APPROVED MINUTES OF THE MEETING

October 16, 2008

1200 Stewart
Alaskan Way Viaduct – Battery Street Tunnel Upgrade
Shoreline Street End Master Plan
Alaskan Way Viaduct – South End
SDOT Art Plan

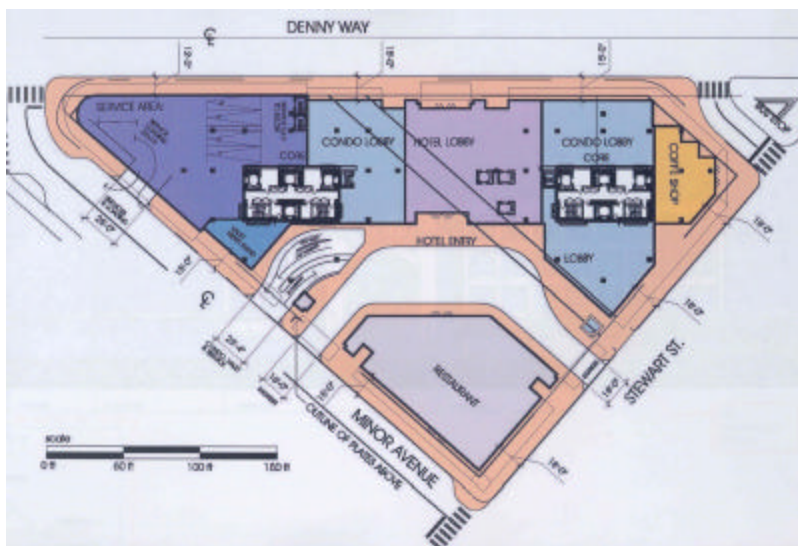
- In general, the sidewalk width and building setback is positive.
- There is one concern that the sidewalk width along the intersection of Denny Way and Minor Avenue, where the fifteen foot sidewalk is reduced to twelve feet. The Commission encourages the designers to provide a constant width along the property edge.

- There is greater concern at the corner of Denny and Minor about the approach of layering vegetation, the craftsman wall, the vent where canopy falls and the façade. The Commission recommends refining this design considering ventilation, noise, use of materials, scale and transparency and the human character of the corner.

- The Commission recommends extending the pedestrian paving across the apron to expand the pedestrian realm.
- There are concerns about the designation of Minor Avenue as the neighborhood pedestrian street with all vehicle entrances and driveways. Suggests consolidating three curb cuts into two. Revise interior circulation.

- The treatment at Denny Way and Minor Avenue is inadequate for such a visible corner. Recommends revisiting.
- Consider incorporating the future pedestrian crossing on Denny Way towards Minor Avenue to the north into the design. While this is not defined, the design could consider some dimensions that will allow this to be incorporated in the future.

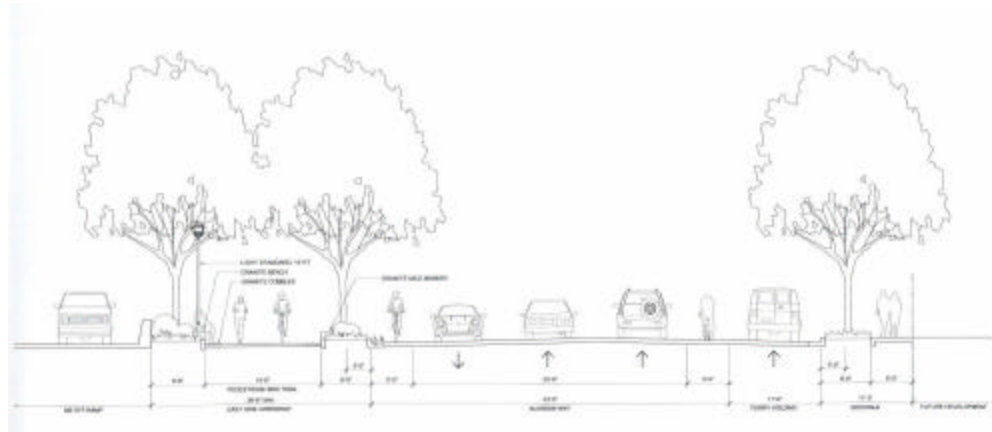
- Appreciates the clarity of design and adaptations to circumstances.
- Applauds the simplification of the landscape design, it reads more strongly.
- Questions design of space east of tail track; understands that thinking is in progress on this great opportunity. There are some safety concerns about “flip flopping” the east-west location of the track and trail.

- Recommends focusing on the west side trail as transitory cycling route and encouraging stopping points on the east trail.
- Questions about relations to the “Great Eight” viaduct alternatives. Encourages the team to keep focused and on track with them. Appreciates the continuous corridor focus.
